**AGENDA PACKET**

**JULY 18, 2023 MEETING**

**AGENDA**

**Tuesday, July 18, 2023**

ENLARGED PICKLEBALL SITE PLAN  
SCALE: 1"=20'

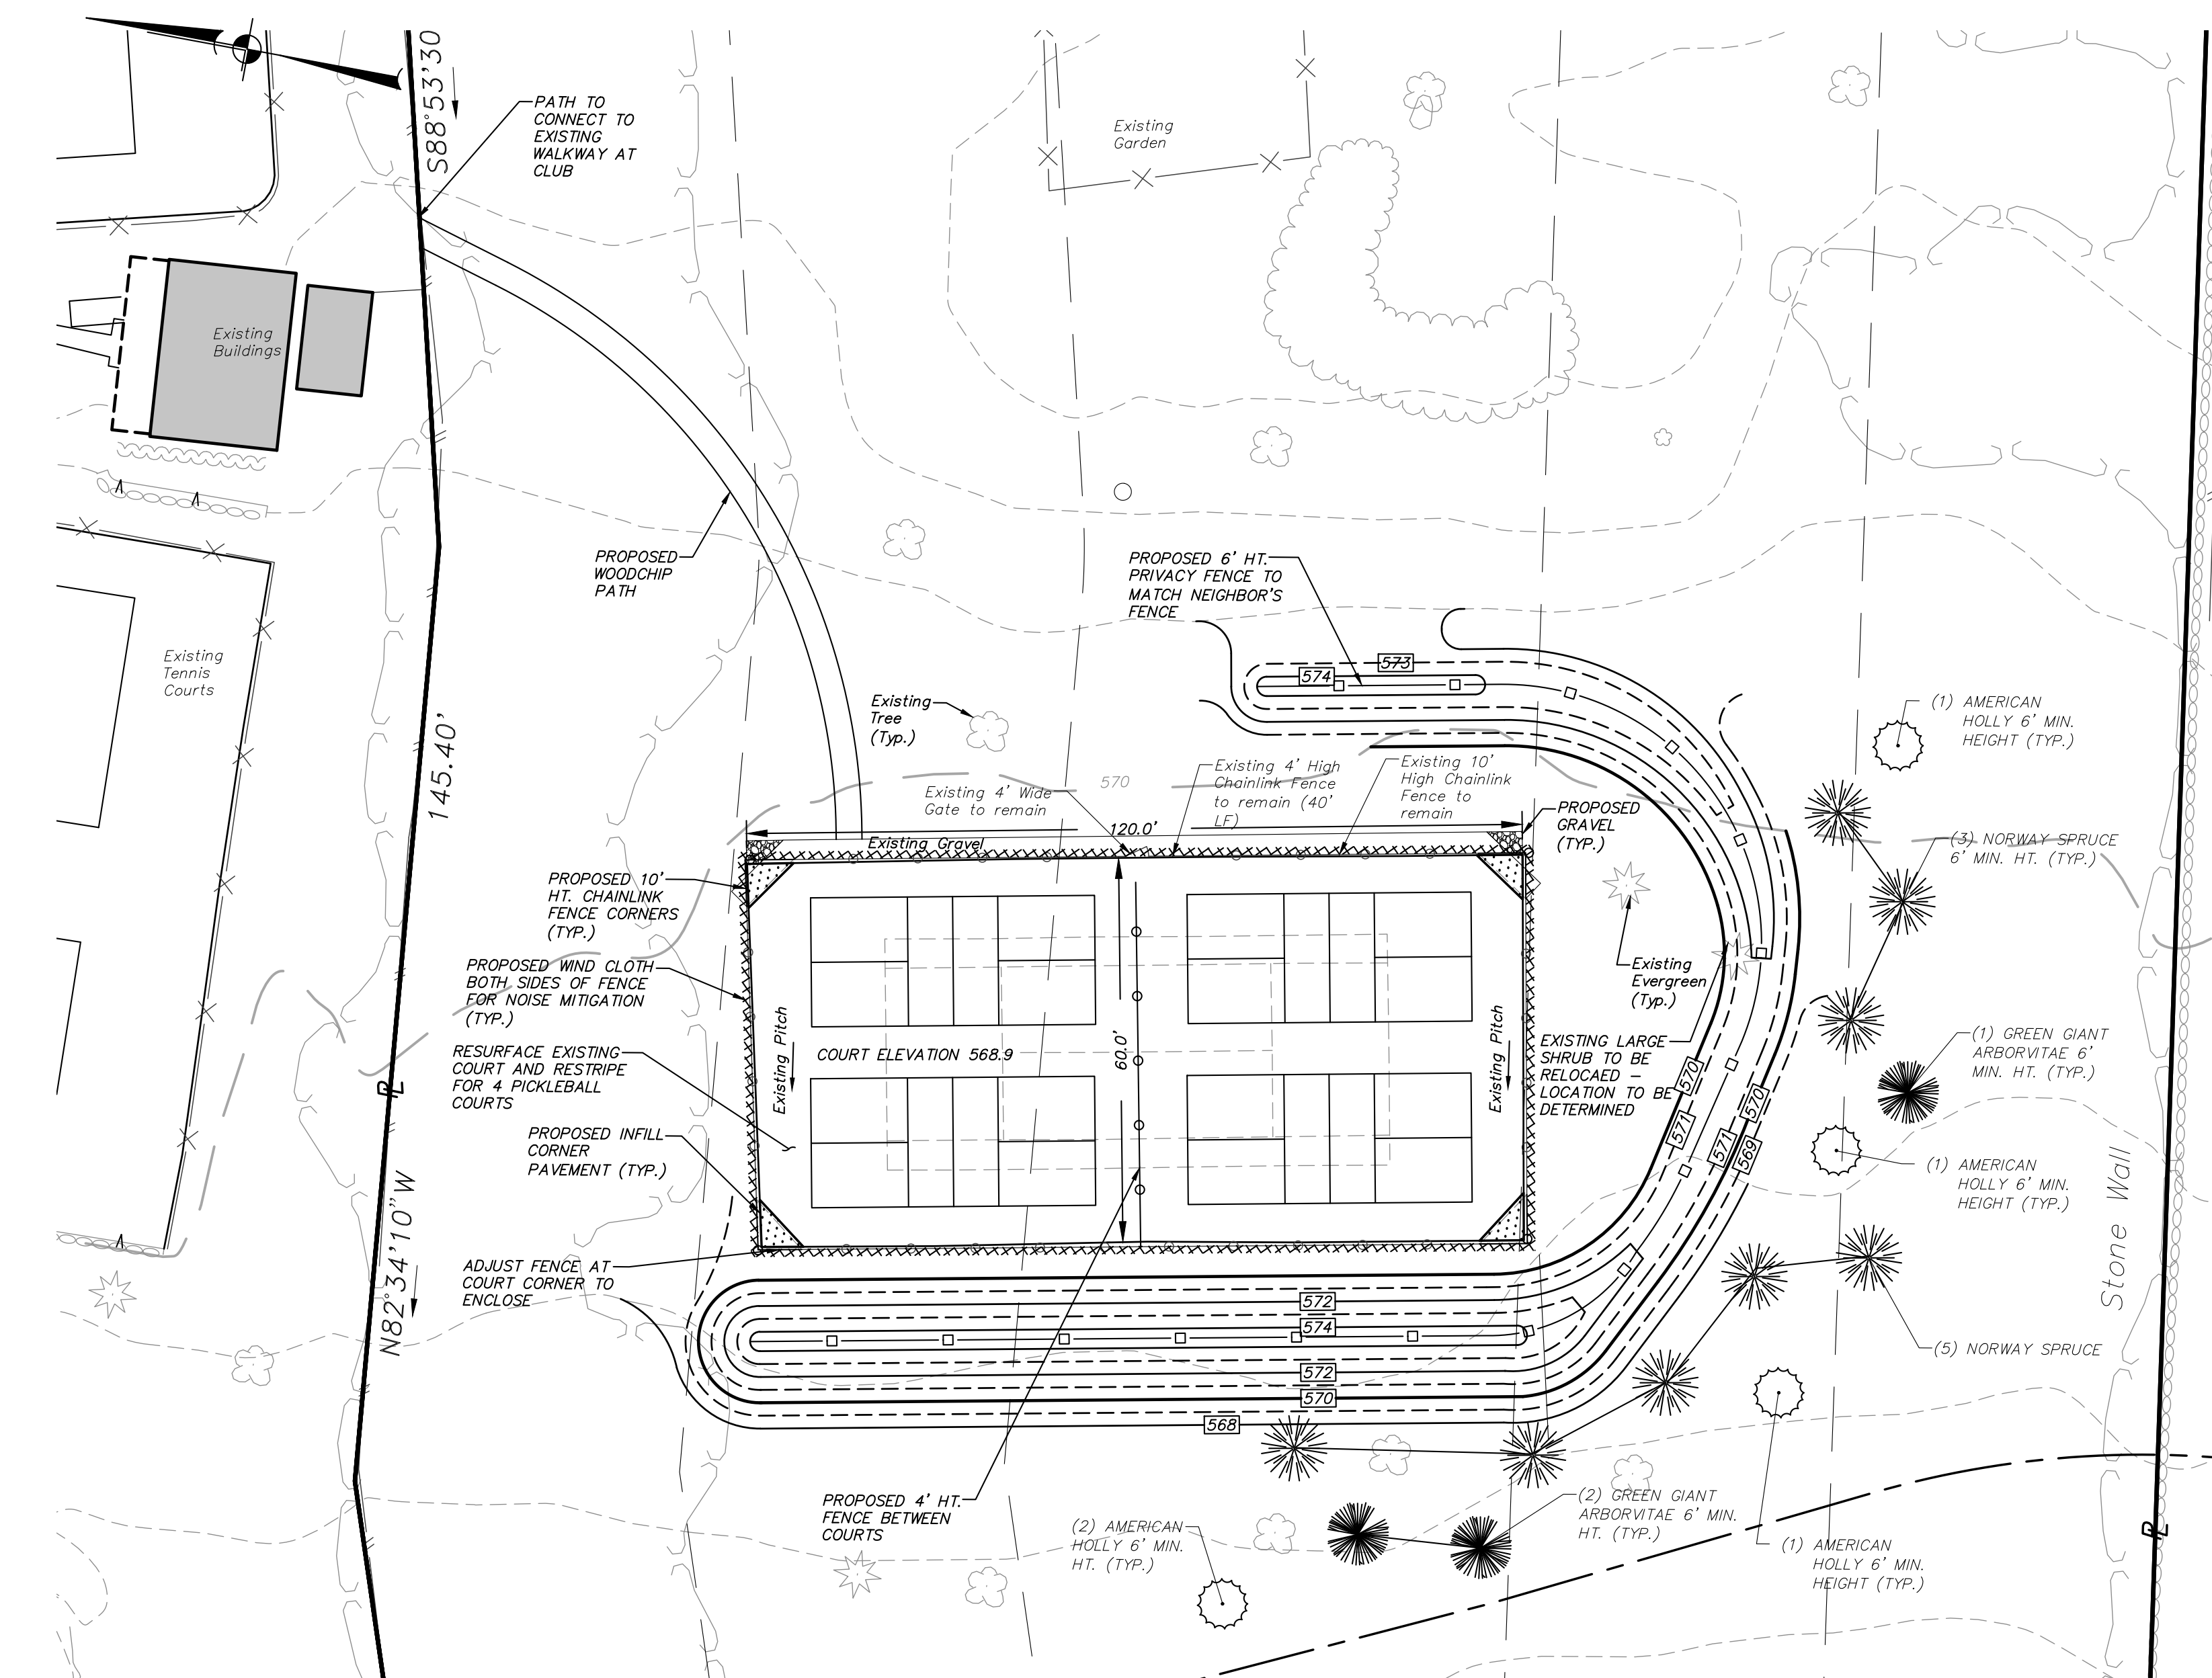
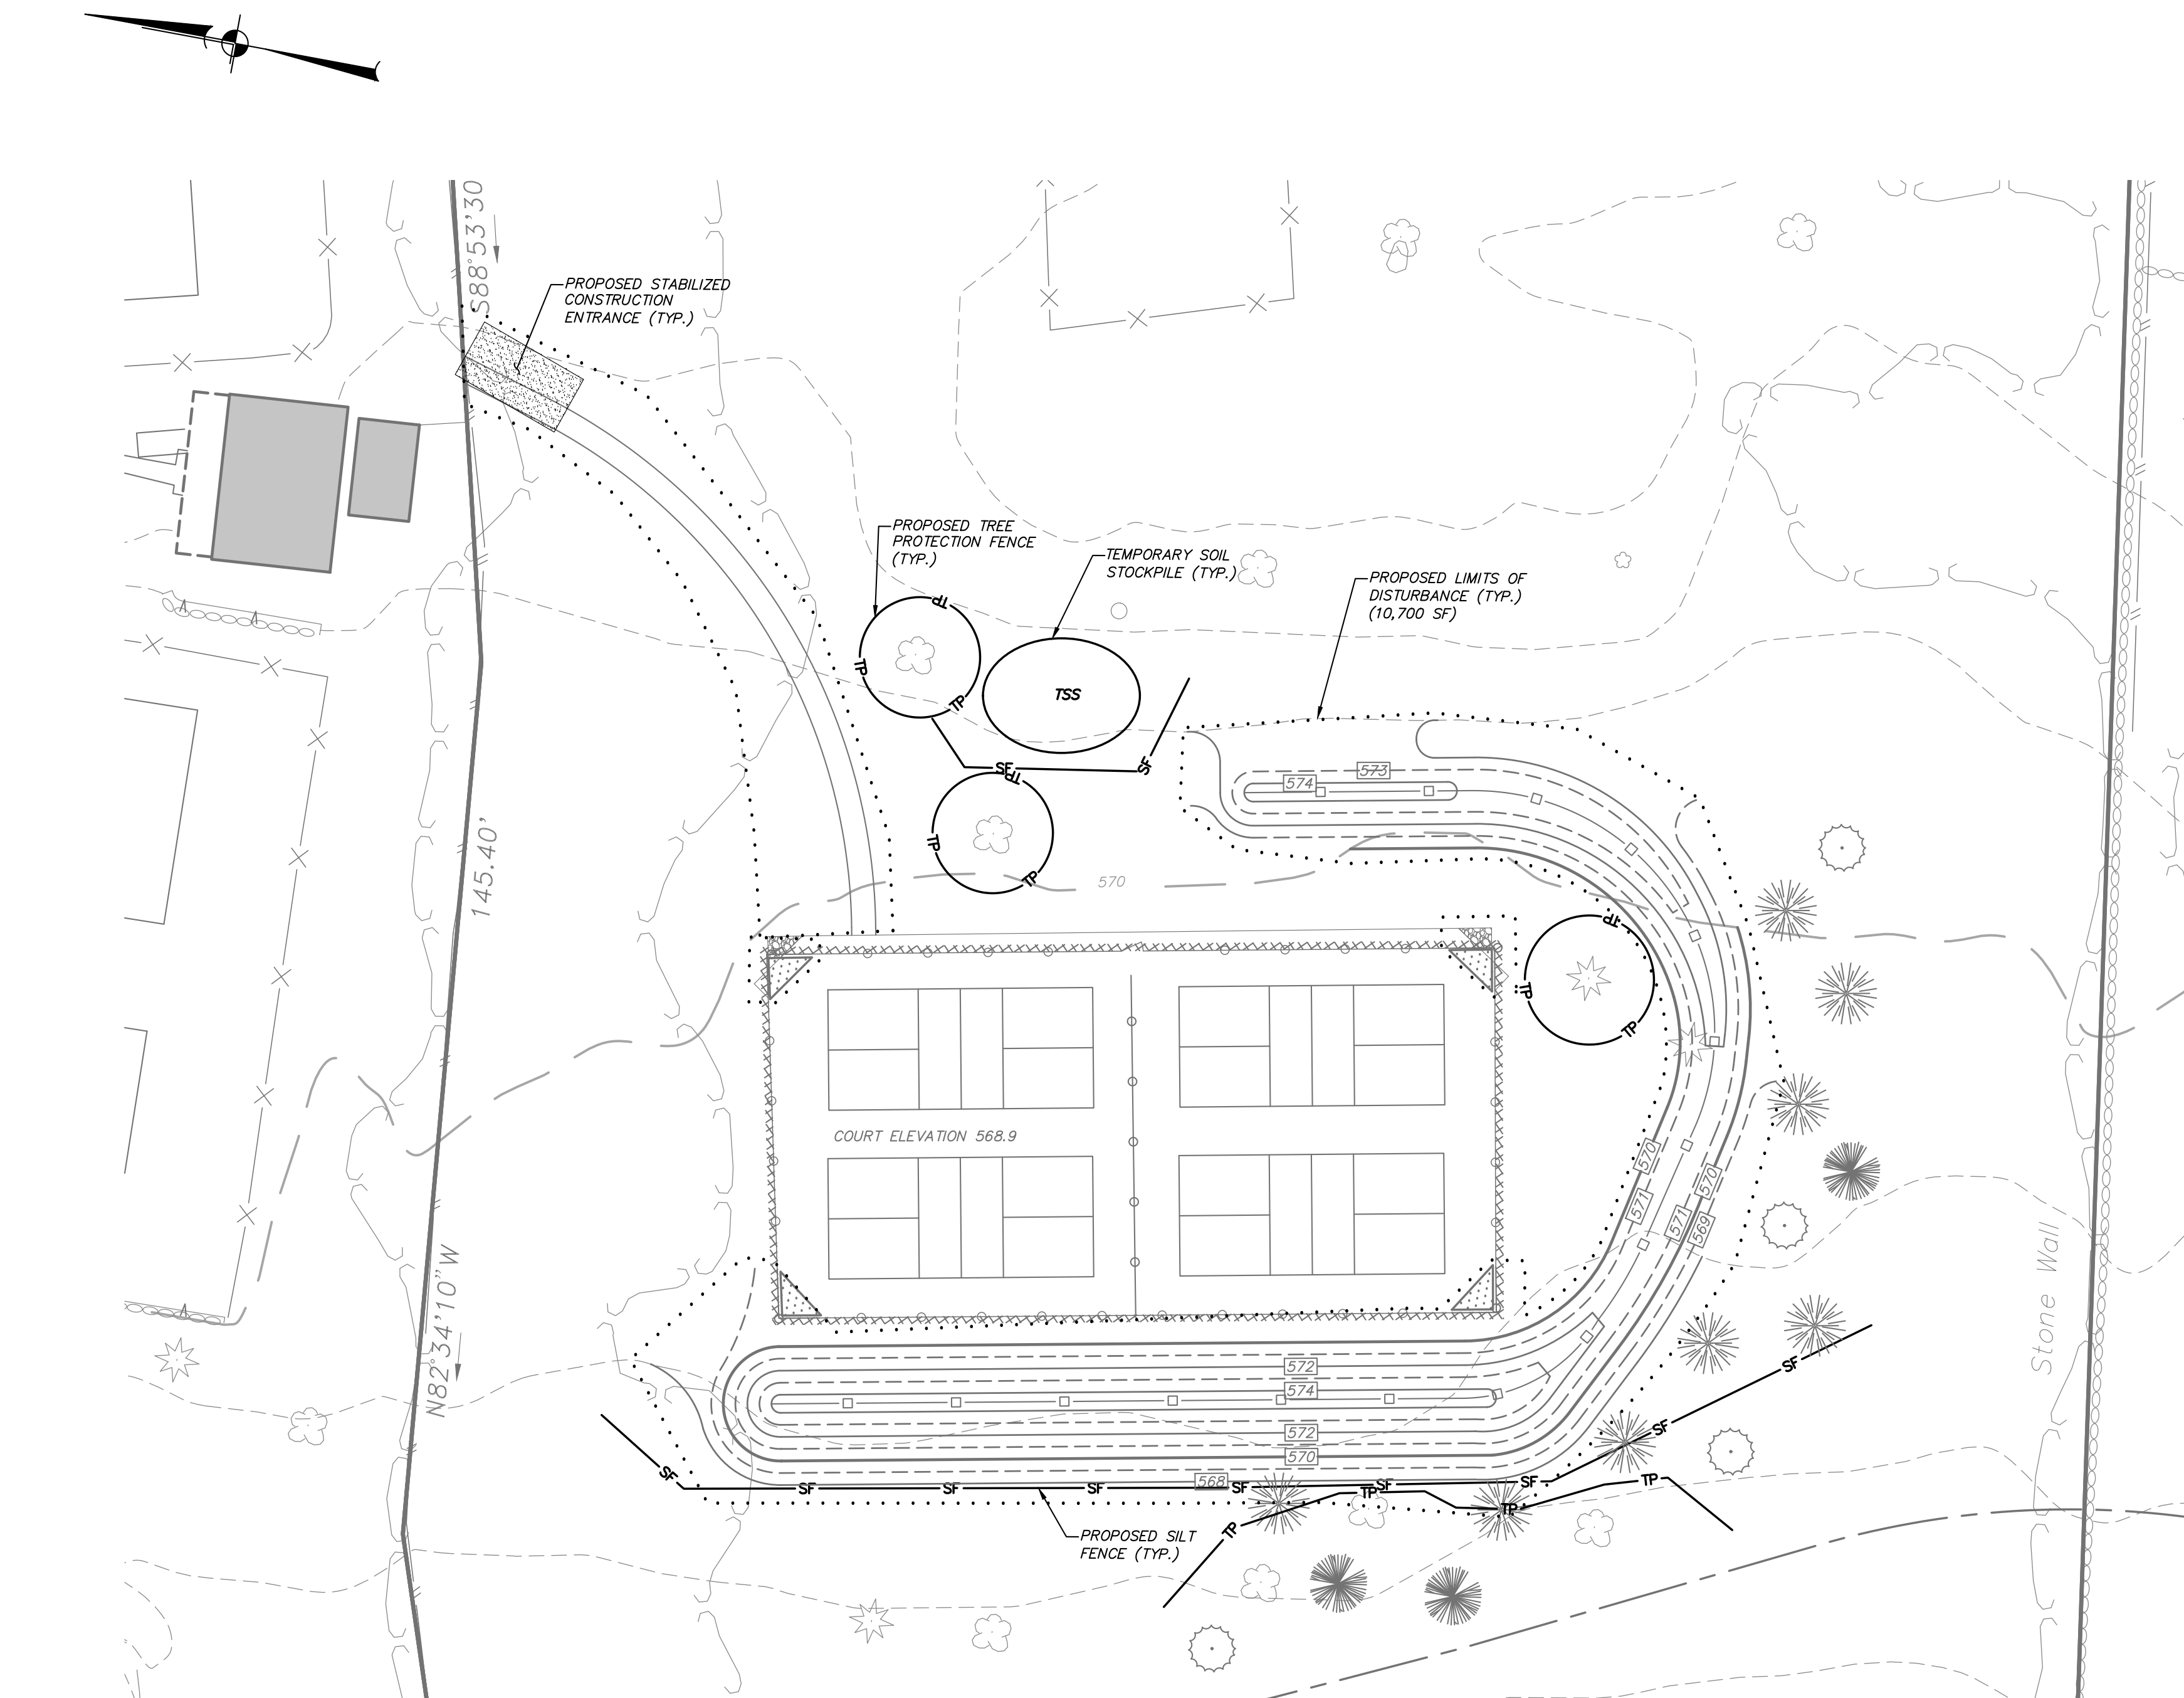
2. The court pitches to the west, toward the proposed berm. Identify how water will drain against the berm; provide spot elevations between the toe of the berm and the edge of the court.

4. The stabilized construction entrance, as shown on the Enlarged Site Plan, does not match the dimensions as provided in the detail.
5. A note shall be added to the plan stating that all soil imported to the site shall constitute unrestricted clean fill, free of non-soil constituent. A signed soil manifest for any imported soil shall be provided to the Town.

6. The proposed privacy fence is noted to "match neighbor's fence"; provide a picture of the neighbor's fence or additional detail regarding material and color; specify which neighbor the note is referring to.
